MIDWEST POOLED FUND PROGRAM

Progress Report - First Quarter 2010 January 1st to April 2nd

Pooled Fund Consulting Summary

This is a brief summary of the consulting problems presented to the Midwest Roadside Safety Facility over the past quarter and the solutions we have proposed.

Figure 1. FLDOT Soil Fill Behind PCB Detail

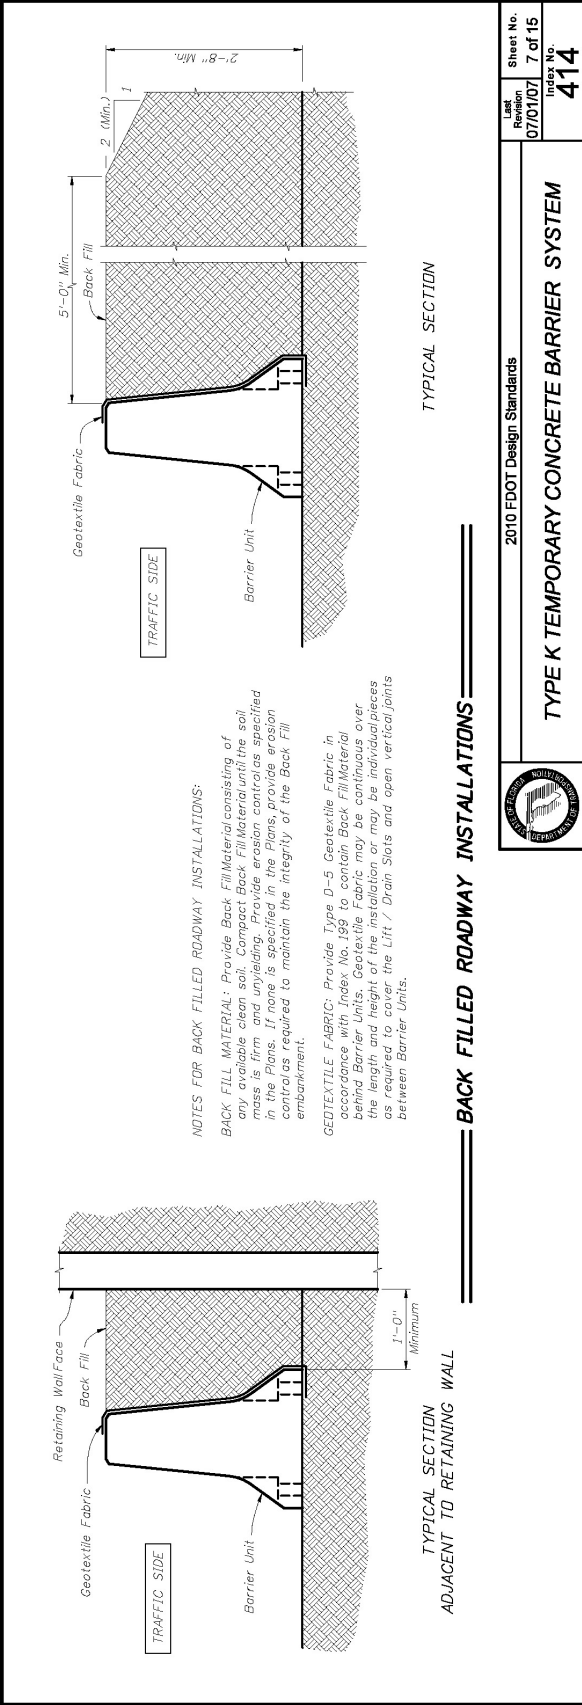
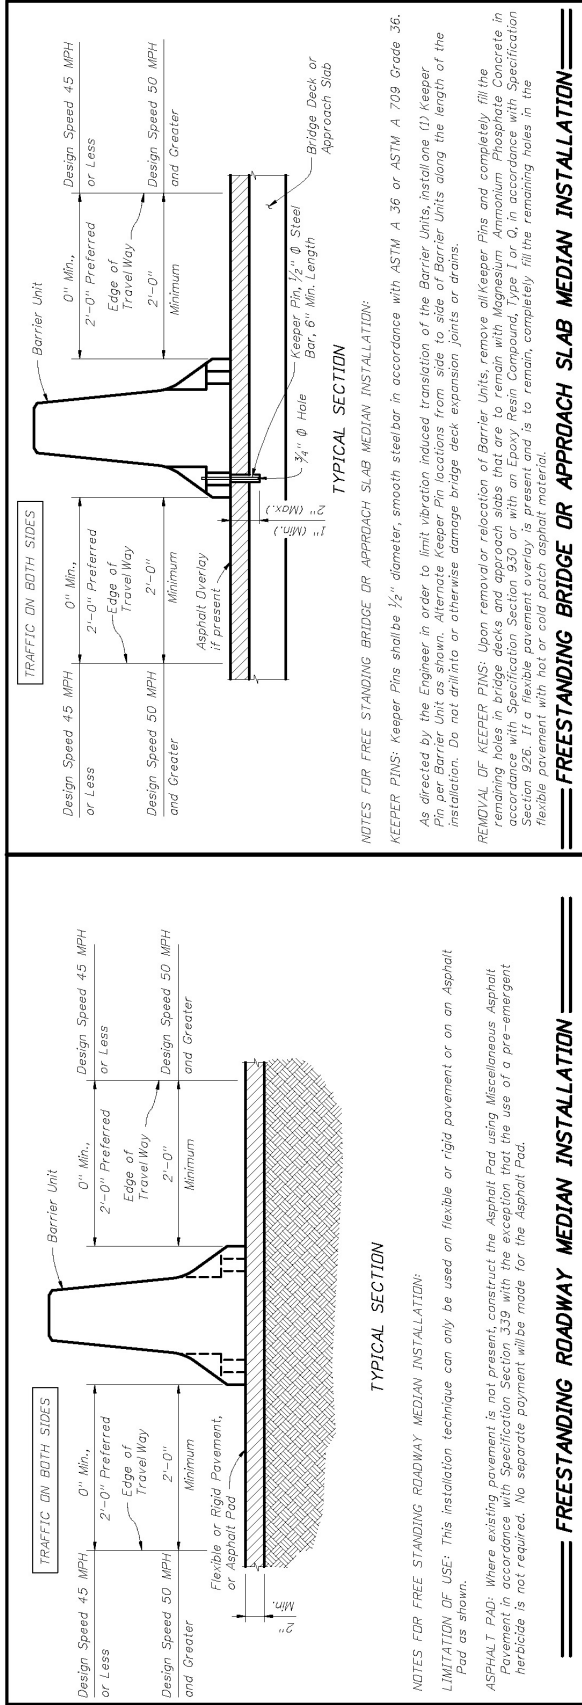
Erik Emerson with WisDOT contacted MwRSF and requested information regarding the use of soil fill behind temporary concrete barrier to reduce deflection.

Attached is the Florida DOT standards for the F-shape barrier. They have a specification in their plans for backfill behind the TCB system. We have review this for Florida in the past and gave it the seal of approval.

Figure 2. F-shape Barrier Bolt Through Tie-Down with Asphalt Overlay

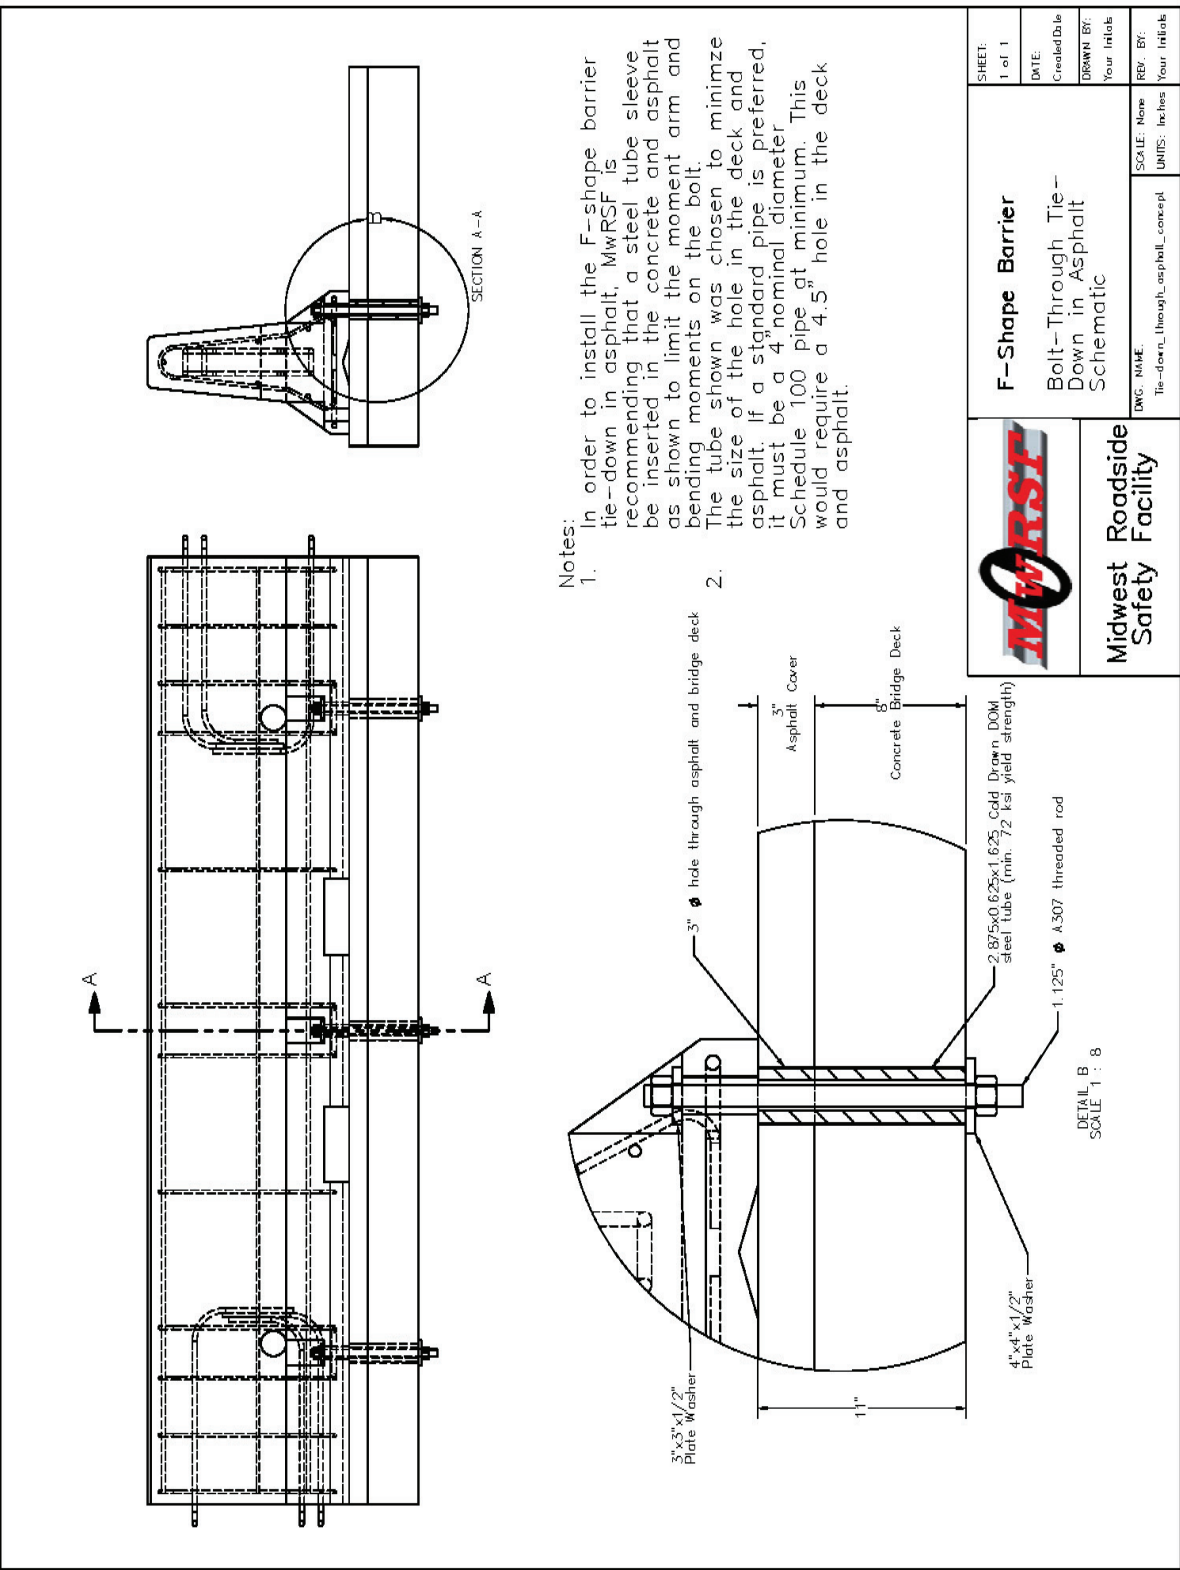
1. When performing the coring, how concerned are we going to be with capturing the slurry and the cores?
2. The detail indicates a 4" nominal diameter schedule 100 pipe can be used versus the 2.875" x 0.625 x 1.626 Cold Drawn DOM Steel Tube but it does not increase the plate washer size, does the plate washer need to be a larger diameter as well.

3. Is the threaded rod to be centered in the steel tube or off to one side? The detail appears to have the rod centered but if a 4" diameter pipe is used and the rod would have room to move around. In our case the barrier is to be mounted with one edge being directly over the saw cut. If the barrier moves as all it could be hanging over the cut edge that we are protecting. Please address.

- a. The plate washer would be larger for the 4" schedule 100 pipe. We would recommend a 7"x7"x3/4" plate washer for the larger pipe.
3. Is the threaded rod to be centered in the steel tube or off to one side? The detail appears to have the rod centered but if a 4" diameter pipe is used and the rod would have room to move around. In our case the barrier is to be mounted with one edge being directly over the saw cut. If the barrier moves as all it could be hanging over the cut edge that we are protecting. Please address.

- a. We intend the rod to be centered in the hole as much as possible. You are correct that with the larger pipe size you can expect a shift of the barrier due to the extra room. This distance would be a maximum of 2". Thus, we would recommend that you allow for 2" of additional room on the back of the barrier adjacent to the saw cut to account for the additional translation. I also want to note that you should not be installing this system with the back of the barrier flush with the saw cut. The design was developed and tested for use with a minimum of a 1" gap between the backside of the barrier and the edge of the concrete. As such, we would recommend that you keep the 1" gap for all installations and increase the gap to 3" when using the larger pipe.

Figure 4. Revised Cable Anchor Bracket CAD

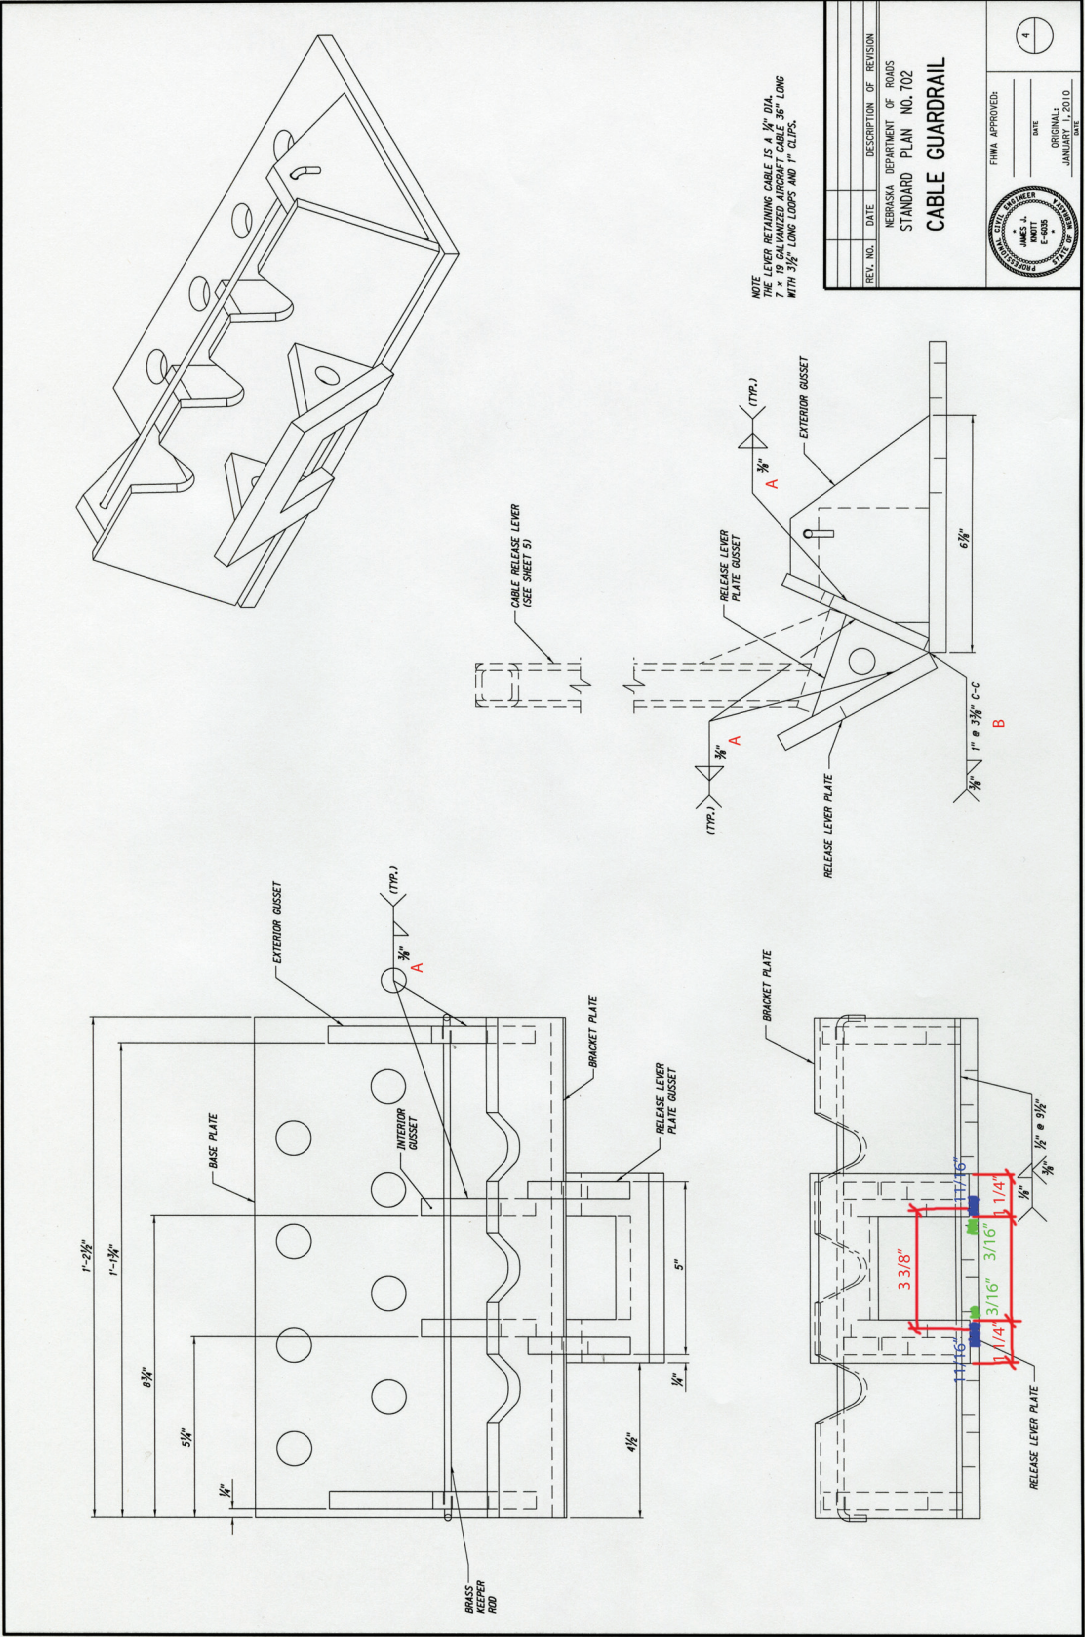
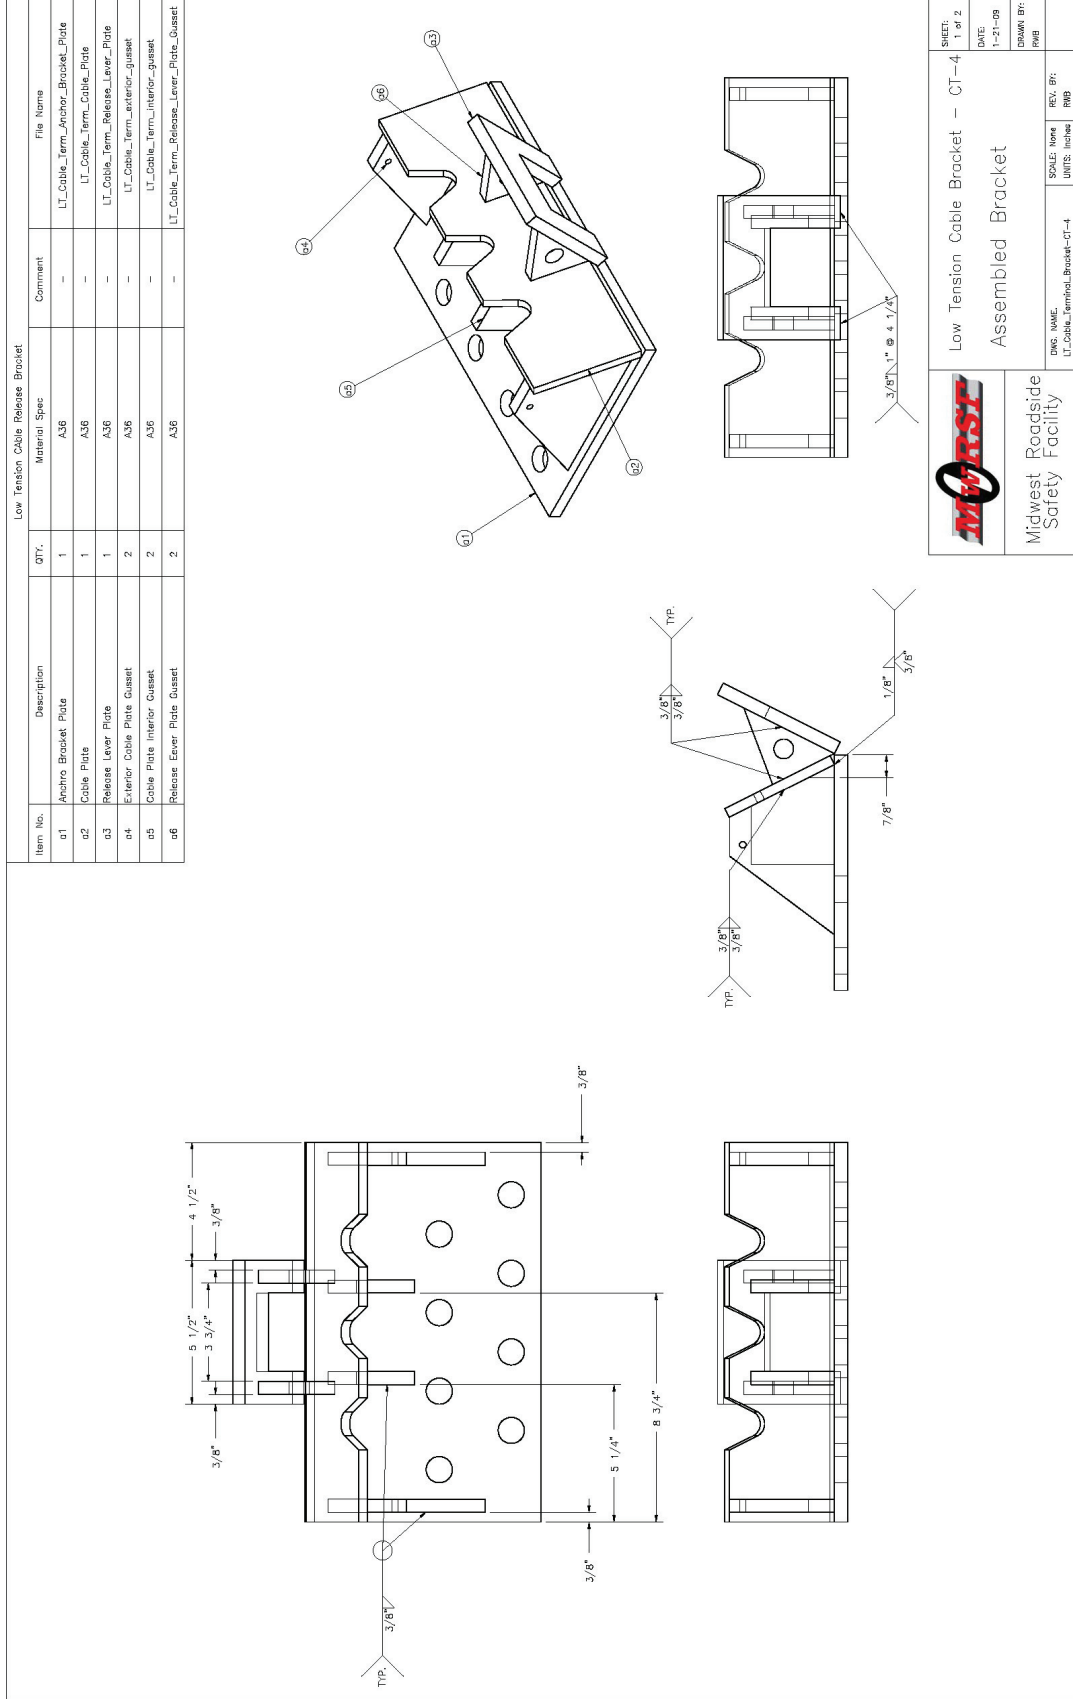
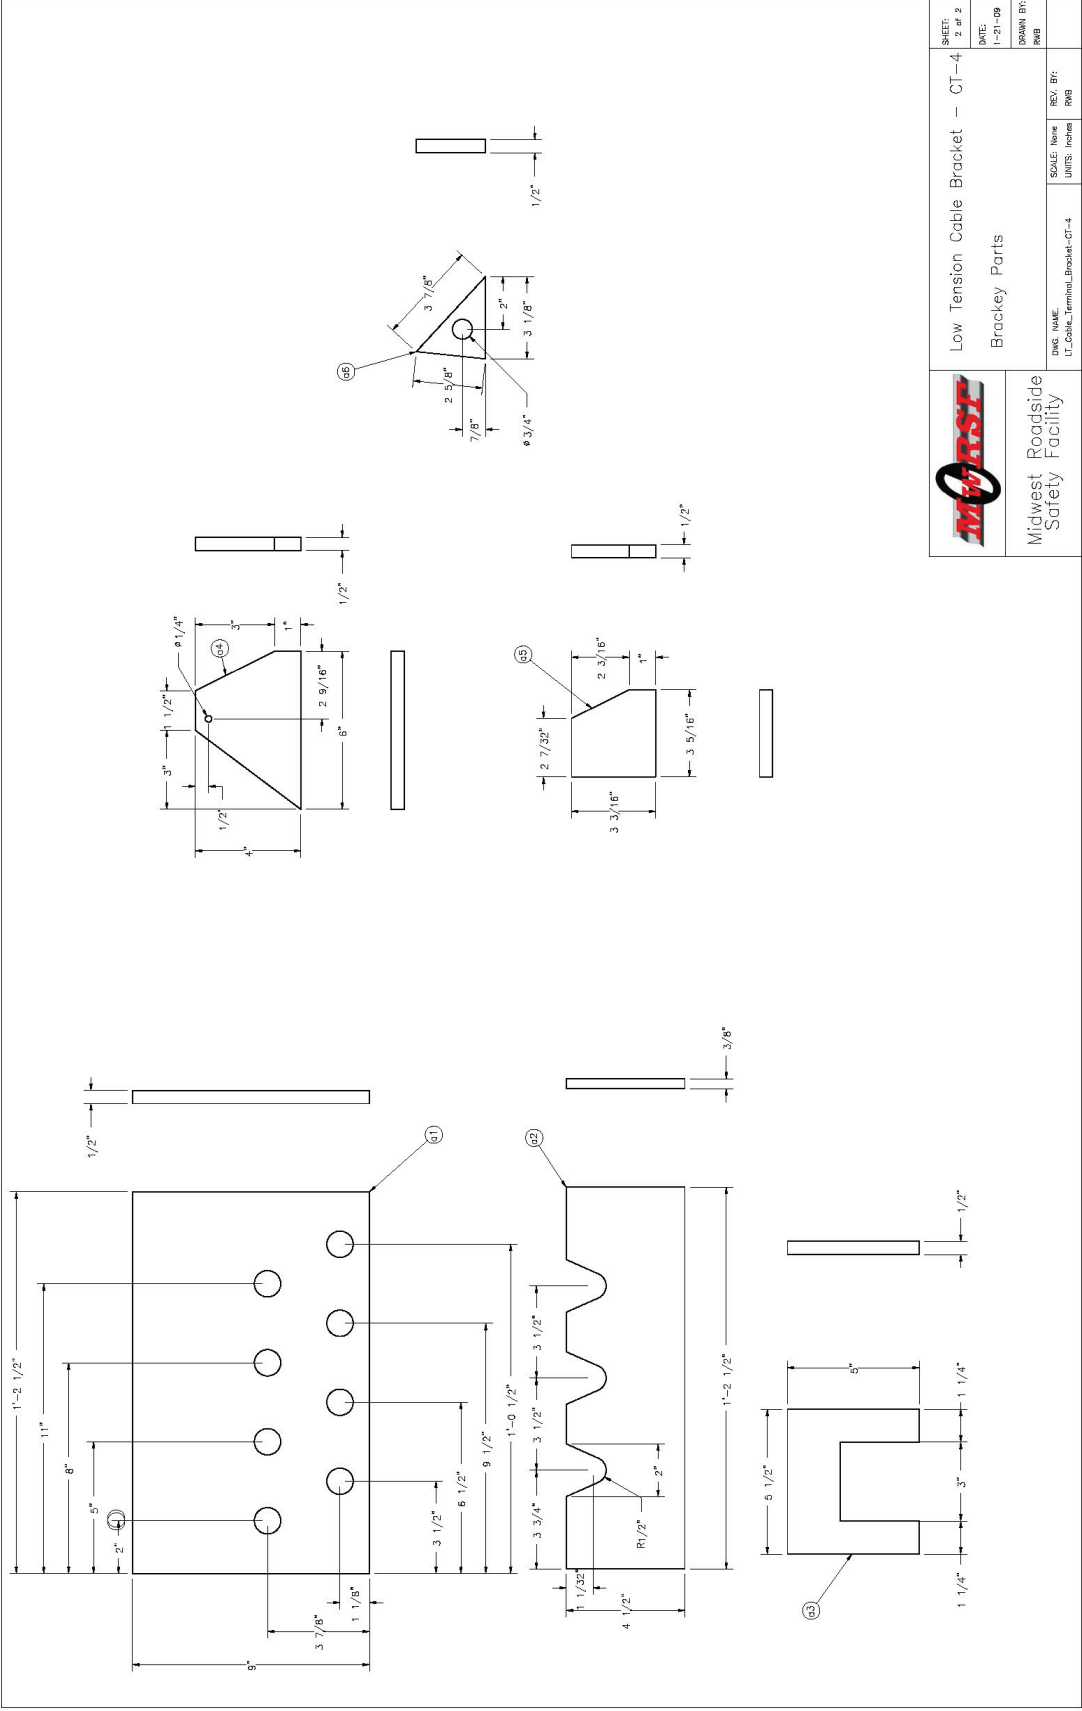
We found a bolt in these holes of report TRP-03-192-08 Figure A-2 Cable Terminal Detail, sheet 2 of 12.

- This is another error in our CAD. The weld callout should read “ 1” @ 4 1/4” C-C”. This will center the weld correctly on the release lever plate.
- I have reviewed the original CAD for the bracket welds and you CAD which appears to be based on it. The weld labeling is confusing and not entirely consistent with what was built. As such, I have drawn a revised detail that should help clear the confusion. Note that some of the dimensions have changed as well. I put in the space for the 3/8” welds that was lacking as well.
